Subject: **Request for Modification to the Section 404 Individual Permit and Section 401 Water Quality Certification and Application for Jordan Lake Riparian Buffer Certification** for the proposed Greensboro Eastern Loop from US 70 Relocation to SR 2303 (Lawndale Drive), Guilford County, Division 7. WBS Element No. 34821.1.1, TIP Nos. U-2525B and U-2525C.

**Subject:** Minutes of the Interagency Hydraulic Design Review (4b) Meeting on November 12, 2015 for U-2525C, Guilford County

**Subject:** Final Minutes of the Interagency Permit Drawings Review (4C)  
Meeting on October 19, 2016 for U-2525C in Guilford County

TIP PROJECT: U-2525C

# U-2525C MOD SITE 1

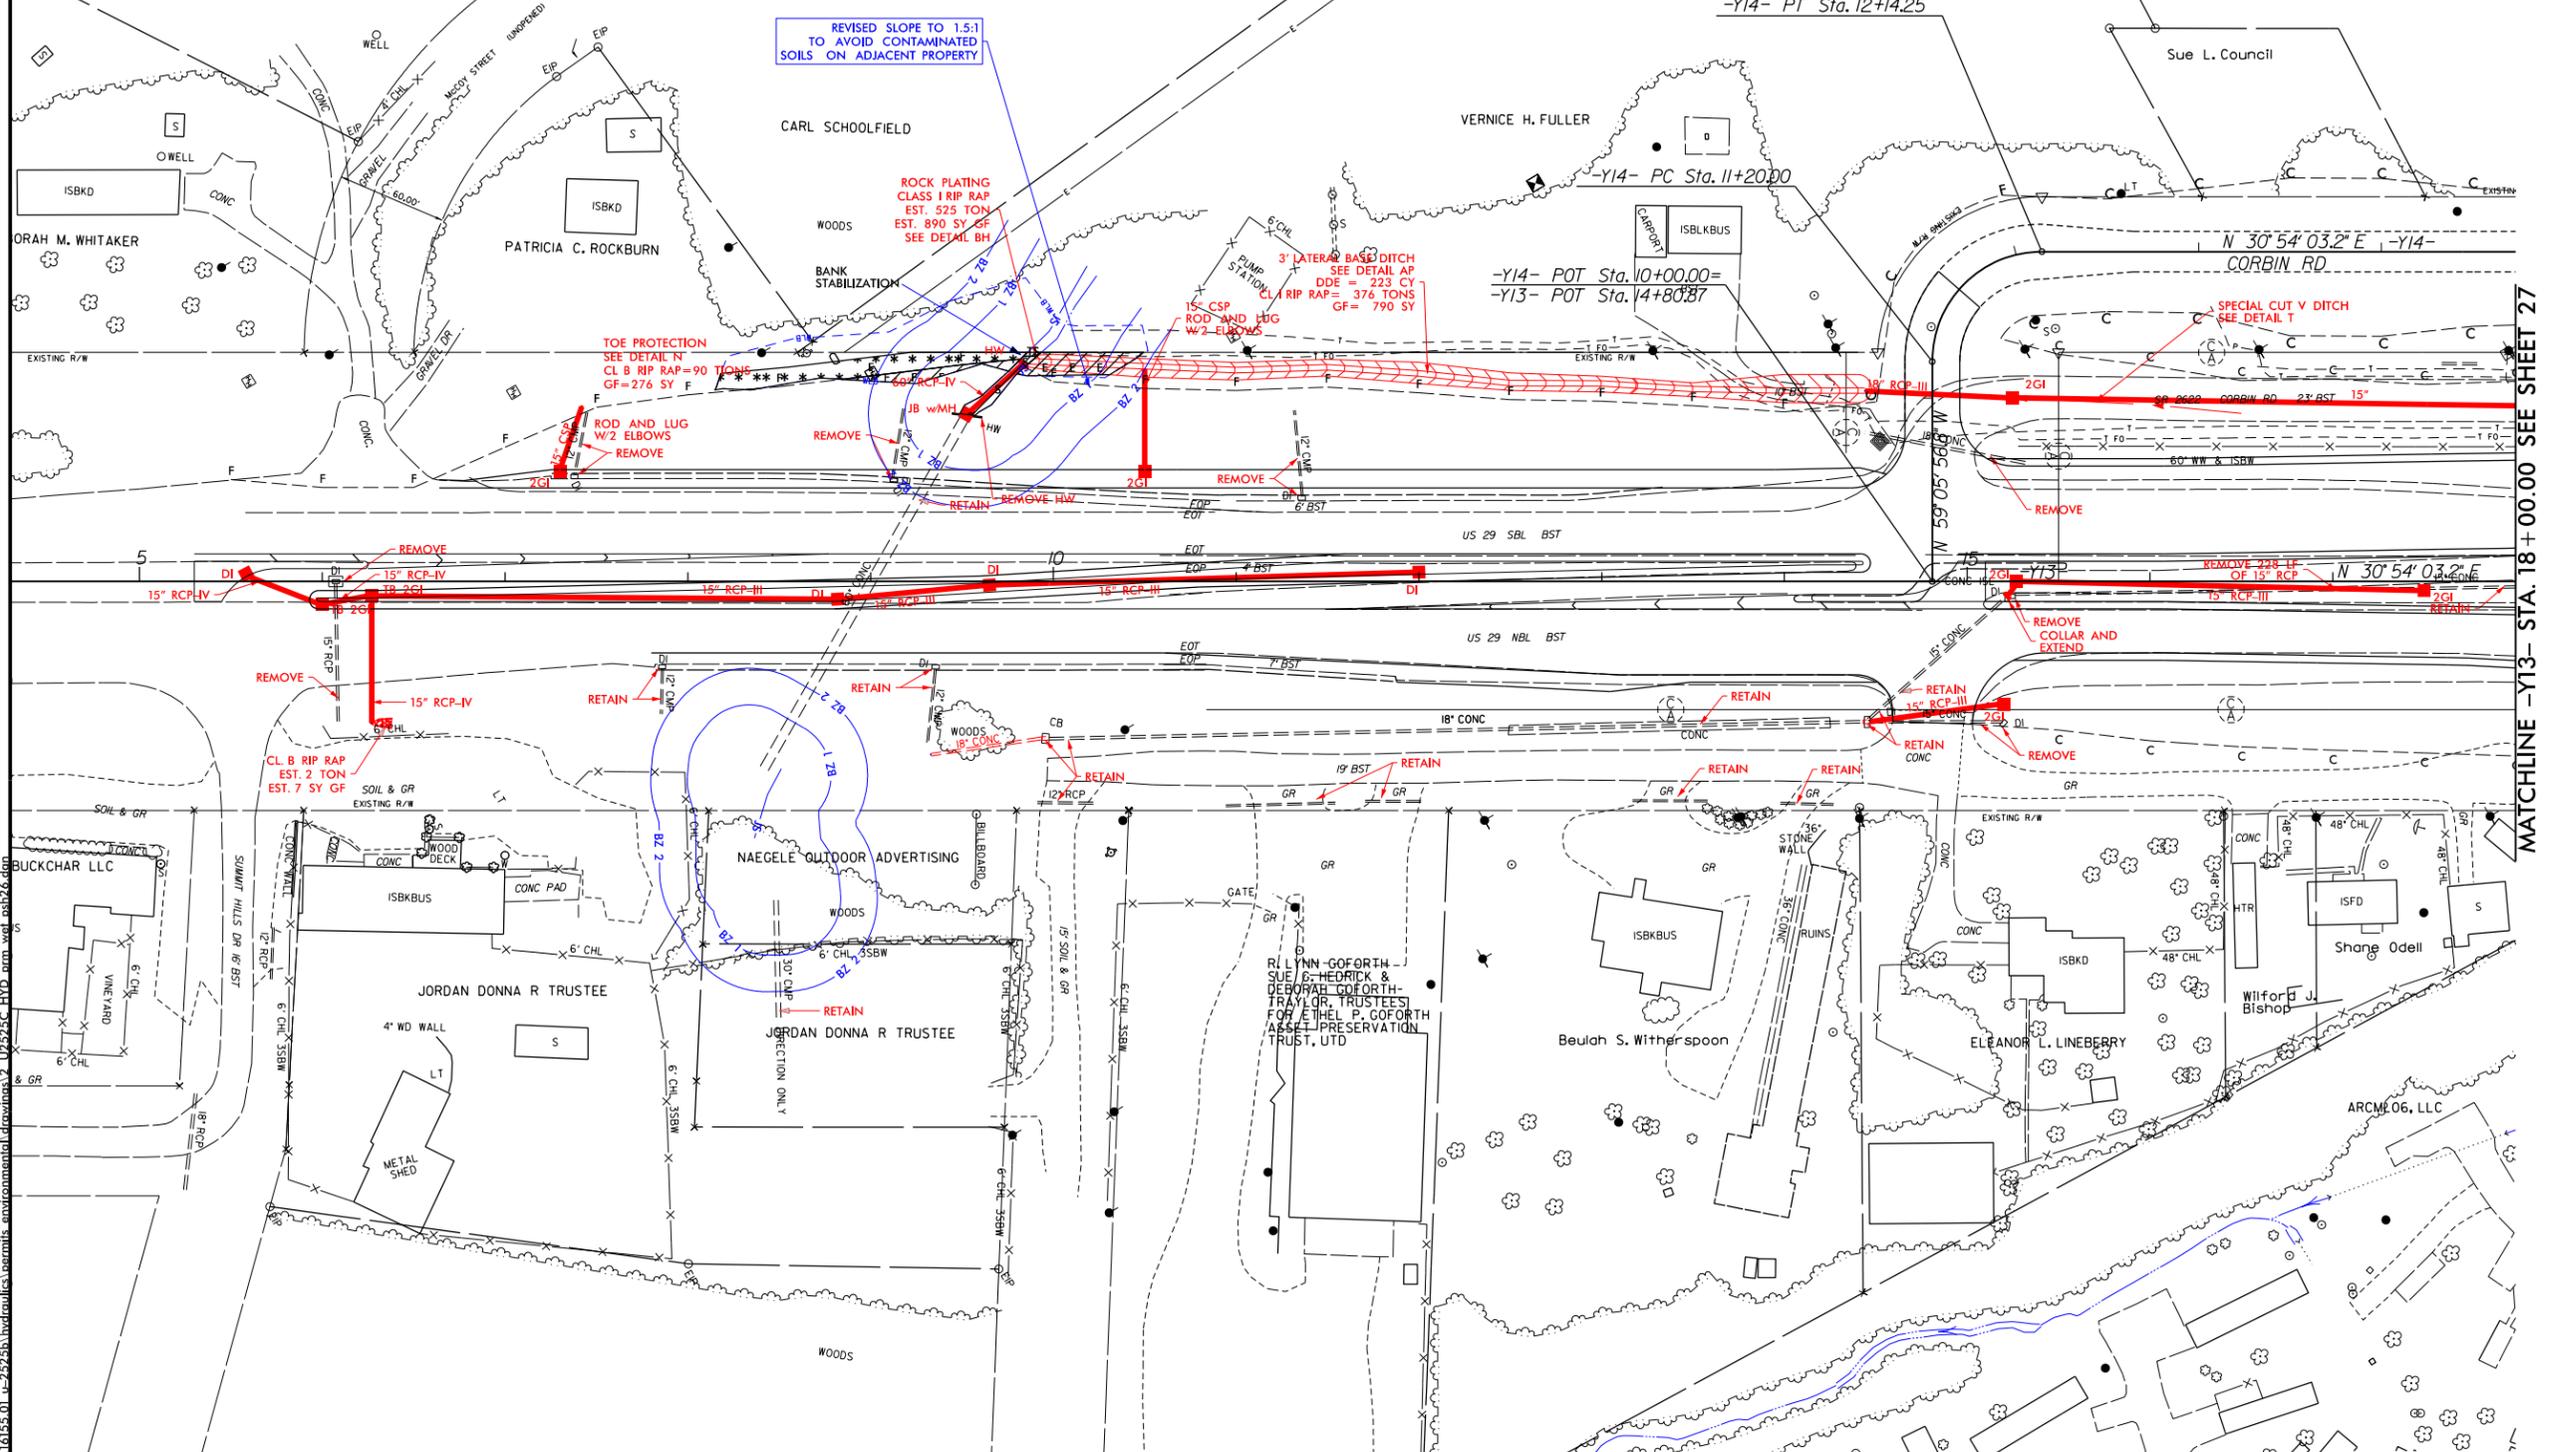
**Site 1:**

Site 1 was not included in the 4B meeting and was not a site in the original U-2525C permit package. Site 1 has been re-delineated since the original delineation was done. Erin Cheely confirmed that previously this site was located just outside of the original delineation. Since Site 1 is a re-delineation, it also has buffer impacts associated with it. The other two sites are grandfathered-out of the buffer rules.

PERMIT DRAWING SHEET 4 OF 14

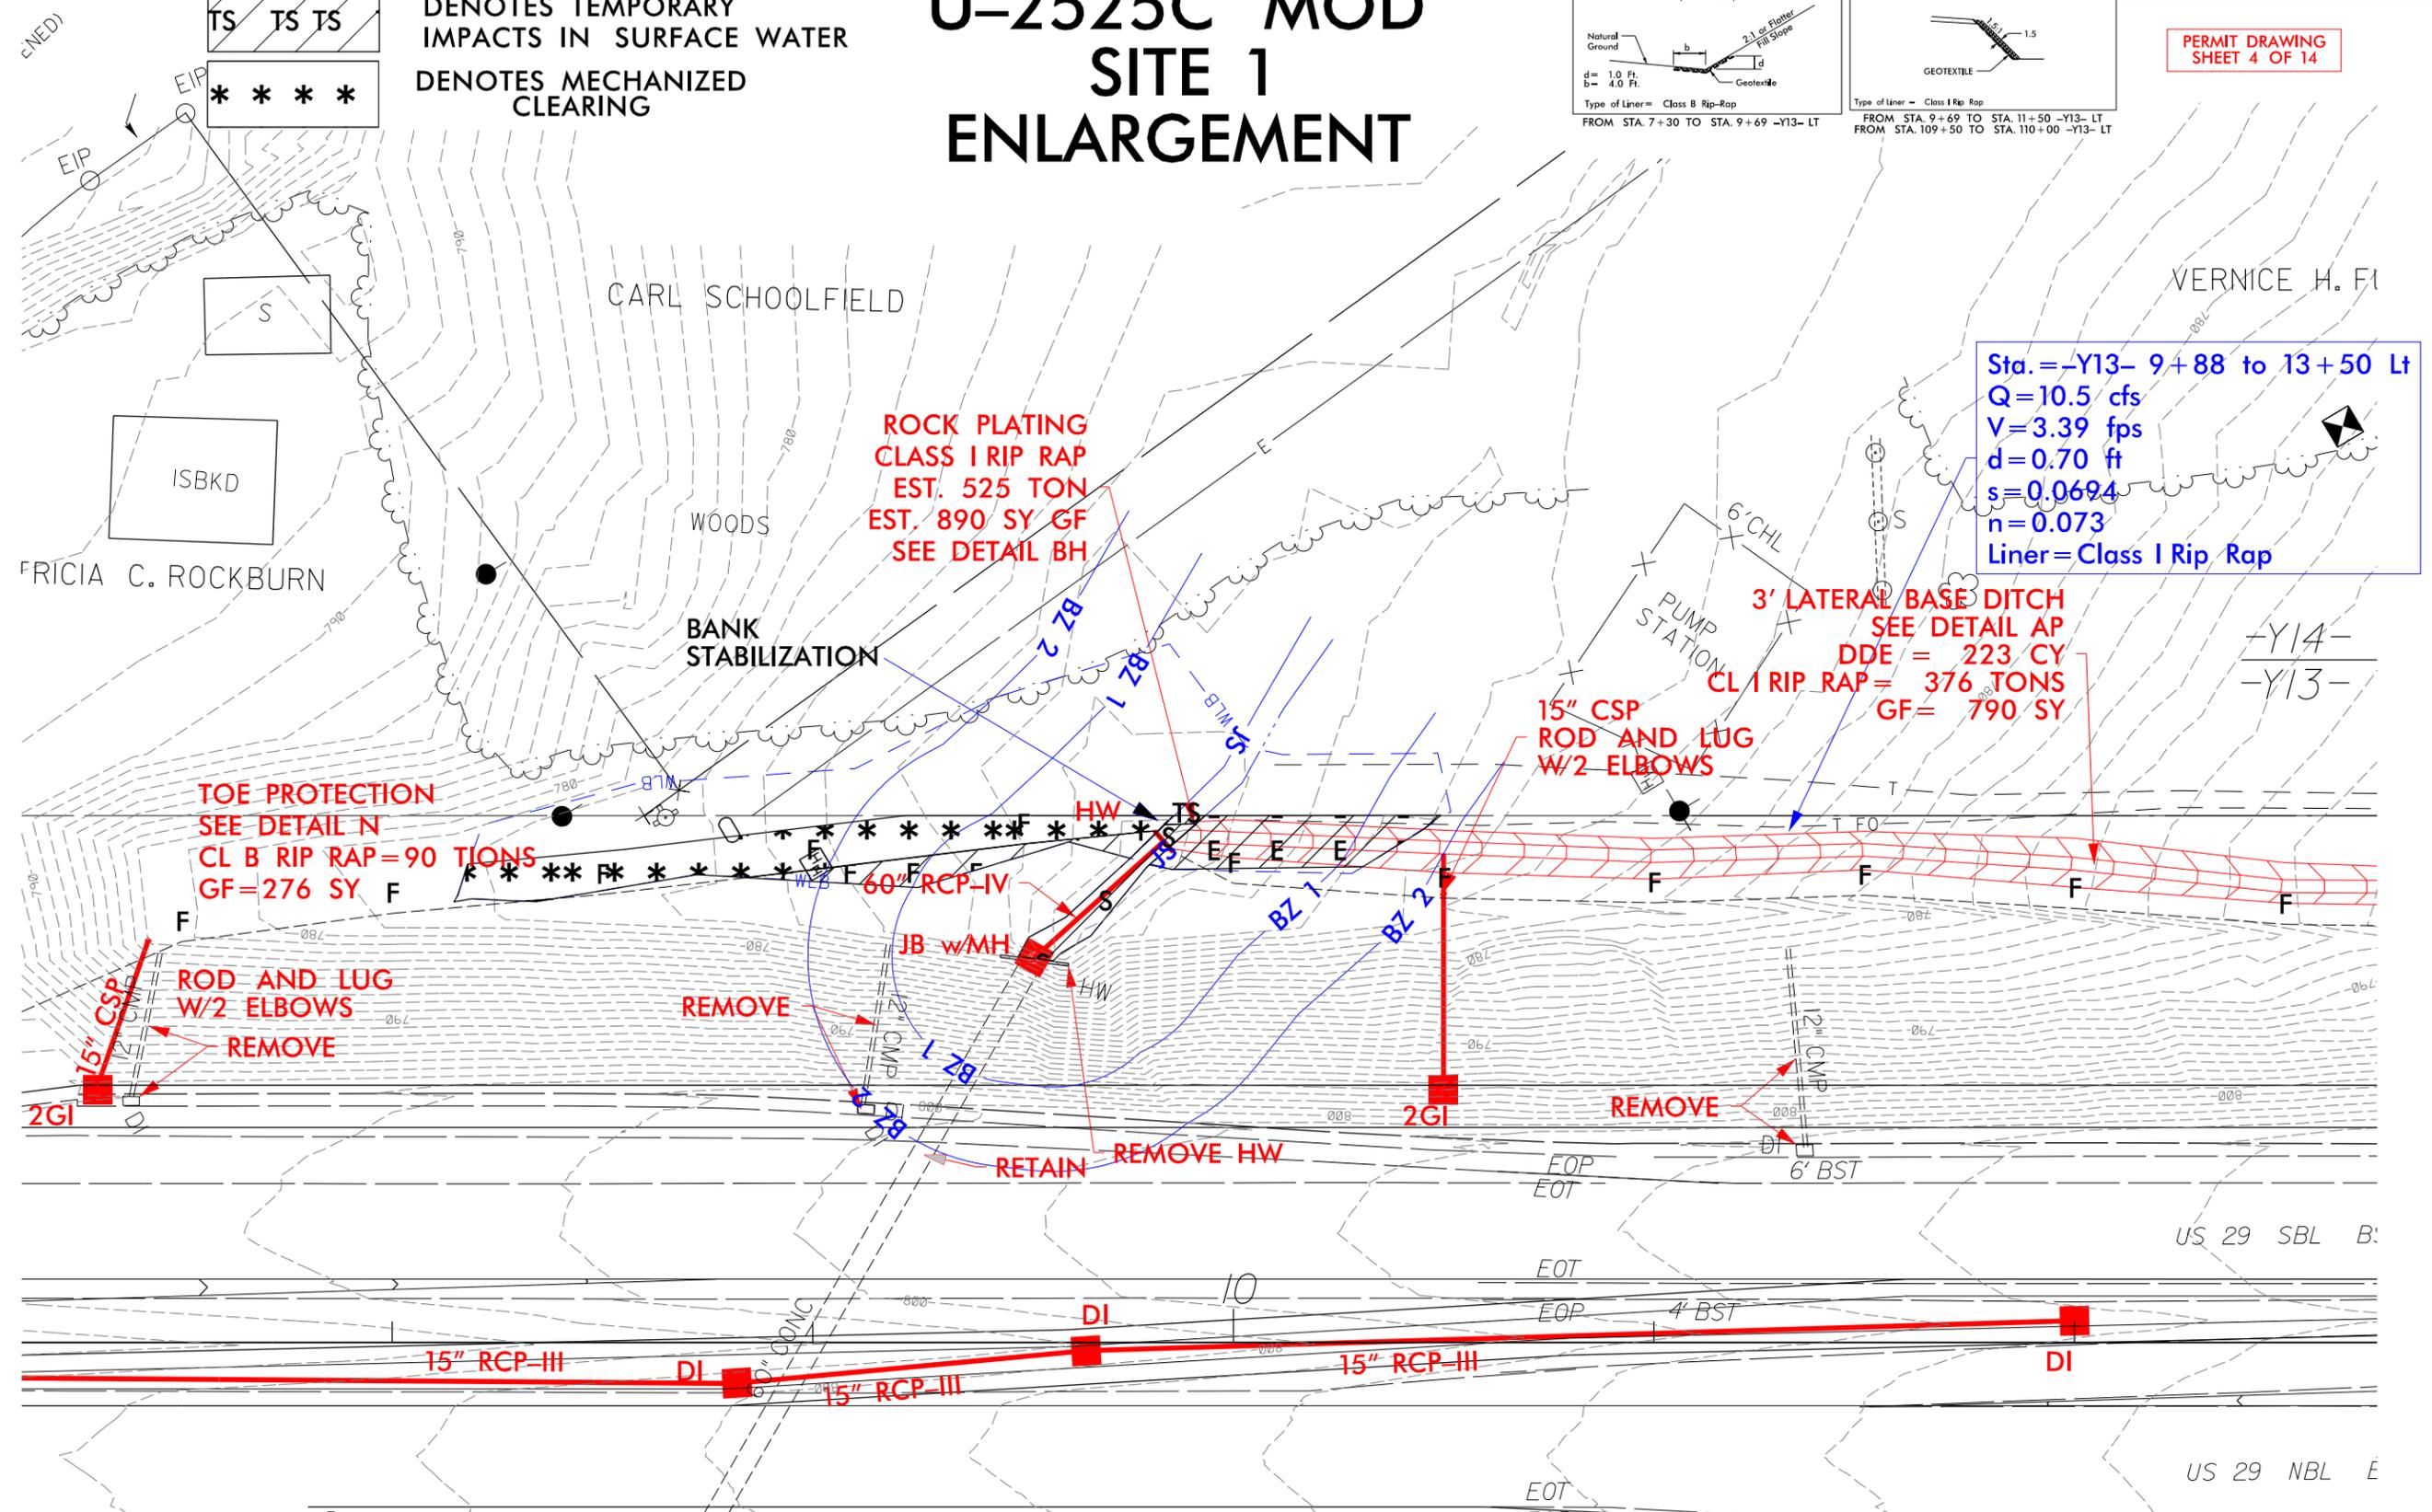
The depicted bank stabilization should be shown on a separate line in the summary sheet as permanent impacts and not as temporary impacts.

Rock plating is prescribed by detail BH on the proposed 1.5:1 embankment next to Site 1; however, detail BH which was not shown. Detail AP prescribes a lateral ditch in Site 1 but was not shown. The revised permit drawings will show details AP and BH.

No mechanized clearing was depicted outside of the fill in wetland from station 8+15 to 9+05 – Y13- left. Revise the drawing to show at least 10' of mechanized clearing in this area.

Since the wetland adjacent to the ditch will be indirectly drained by the ditch, quantify the area not already included on the Wetland & Stream Impact Summary Sheet as a note stating “this acreage reflects draining of the wetland by the ditch.”

Verify the pipe length and adjust as necessary. Tie the slope stakes to the headwall.
